TITLE: Sheet_1		REV: 1.0
嘉立创EDA	Company: Your Company	Sheet: 1/1
	Date: 2023-12-15	Drawn By: Denjhang

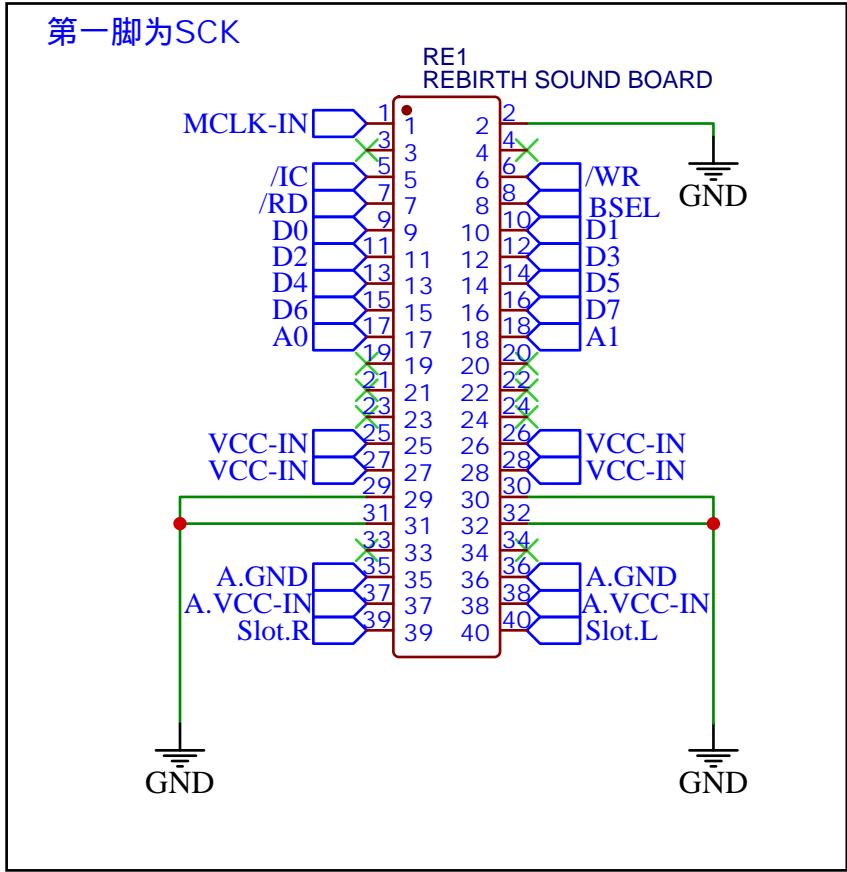
1n电容位置放置错误  
60TK焊盘间距过大  
2023.12.21  
1.焊盘间距已修复，需要再次测量实物  
2.Vbias已添加  
3.滤波电容已更换

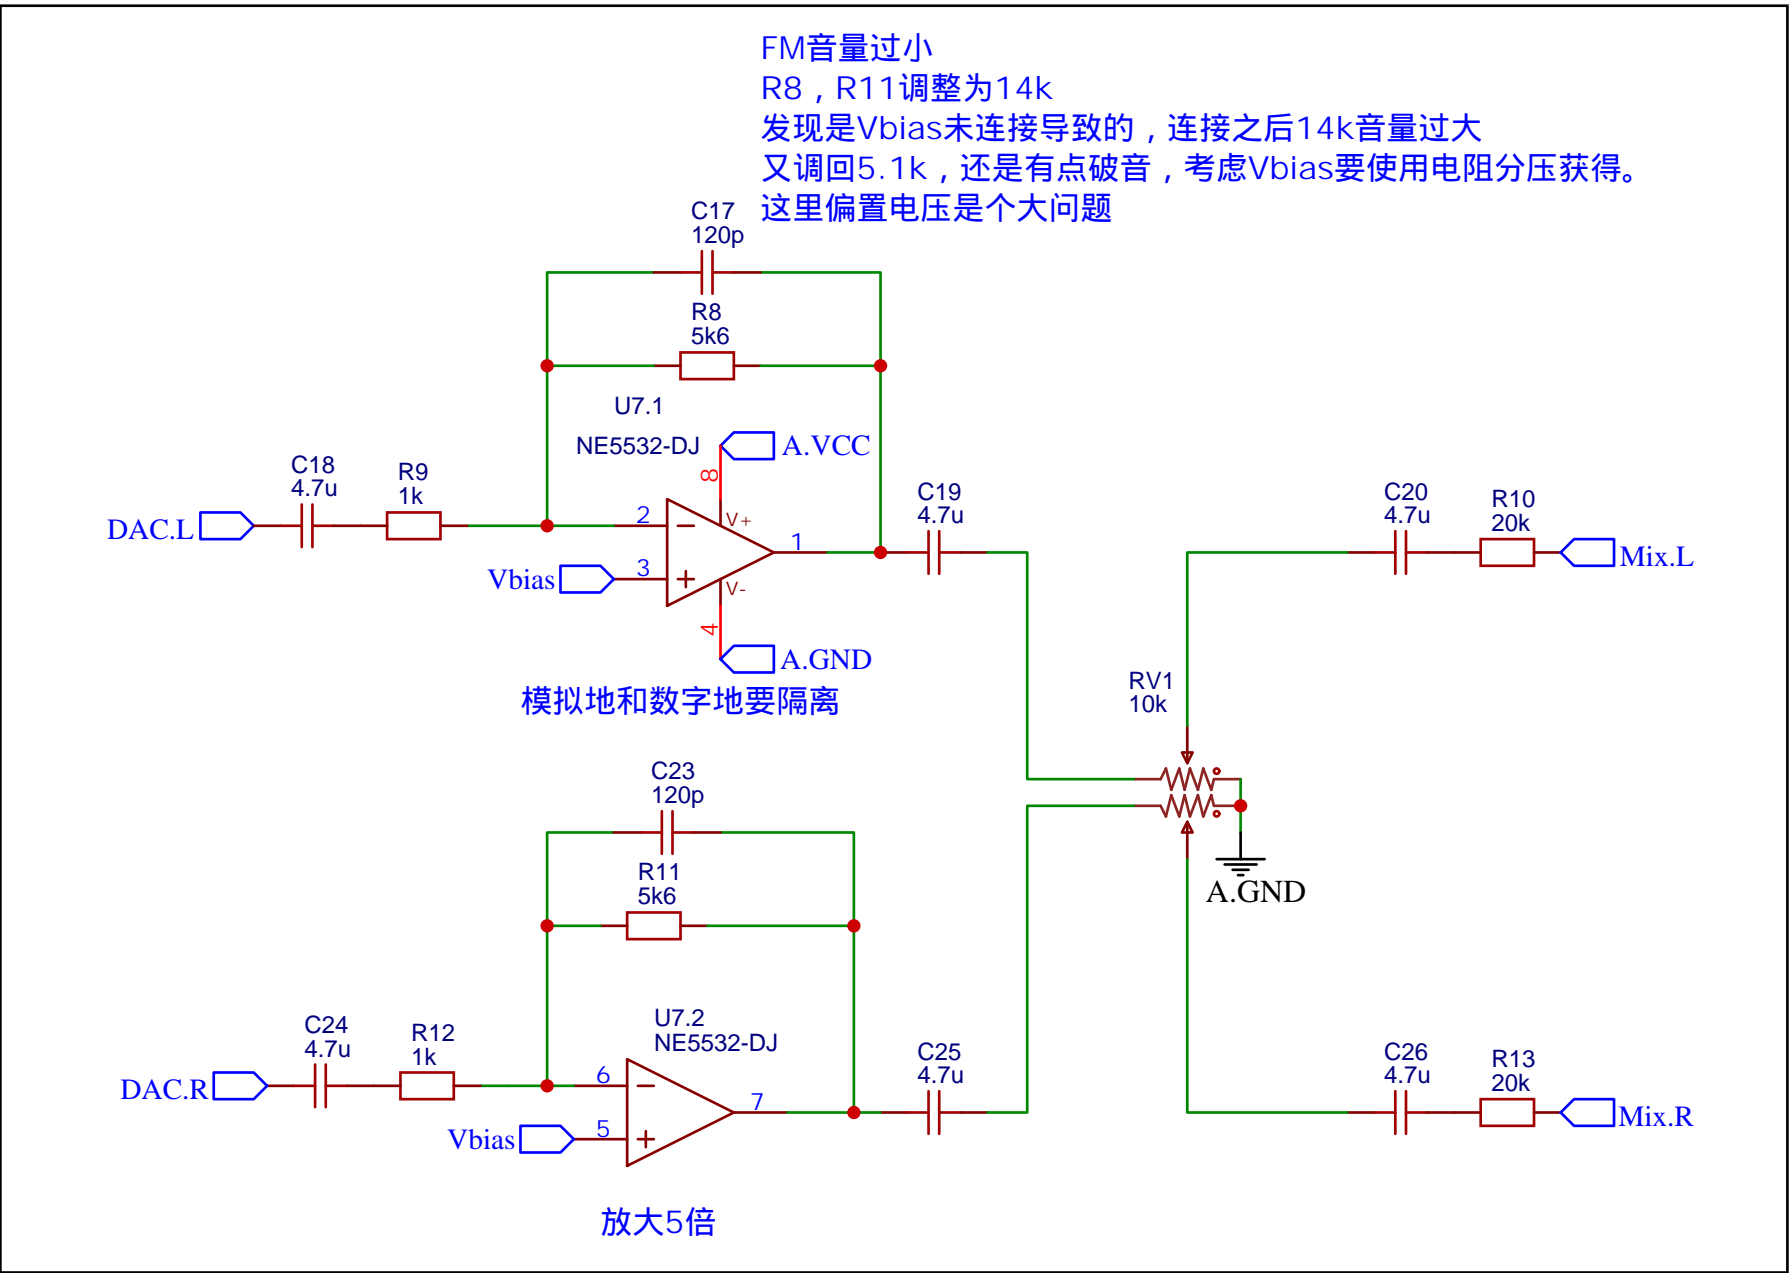
去掉二极管，那个会引起压降
